UNITED STATES PATENT AND TRADEMARK OFFICE

09/537,274

Office Action Summary

Claim Rejections - 35 USC § 112

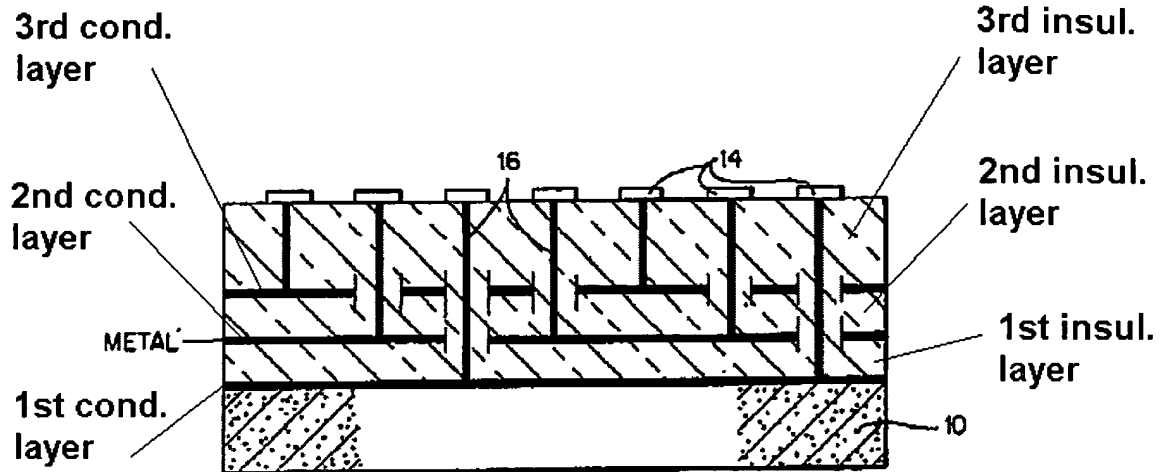
2. Claim 21 is rejected under 35 U.S.C. 112, second paragraph, as being indefinite for failing to particularly point out and distinctly claim the subject matter which applicant regards as the invention.

Claim 21 depends on a cancelled claim. The examiner examined this claim as if it depended on claim 2.

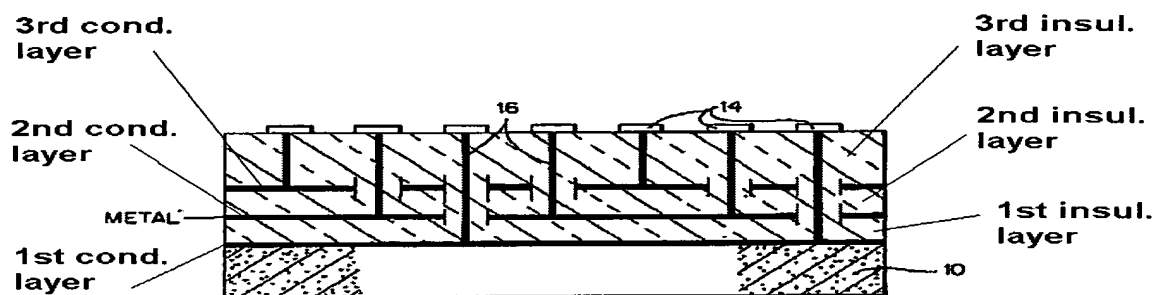
'3117 discloses the claimed invention except for the insulator layers are formed from a BaSrTiO₃ material. It is well known in the capacitor art to form insulating layers from a BaSrTiO₃ material (excellent dielectric properties). It

would have been obvious to one having ordinary skill in the art at the time the invention was made to form the dielectric from a BaSrTiO₃, since it has been held to be within the general skill of a worker in the art to select a known material on the basis of its suitability for the intended use as a matter of obvious design choice. In re Leshin, 125 USPQ 416.

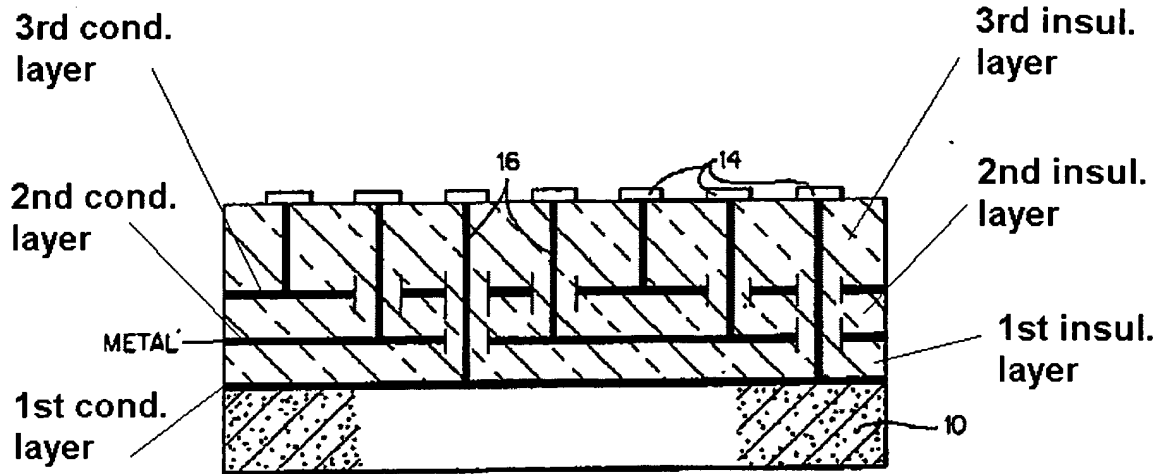
'3117 discloses the claimed invention except for the plurality of vias extending through the substrate to provide electrical interconnection to both a top surface and a bottom surface of the integrated circuit capacitor. It is well known in the capacitor art to extend vias through a substrate to provide electrical interconnections to both sides of the capacitive element. It would have been obvious to a person of ordinary skill in the art at the time the invention was made to extend the vias of '3117 through the substrate to provide electrical interconnections to both sides of the capacitor, since such a modification would decrease the space needed in the electrical system.
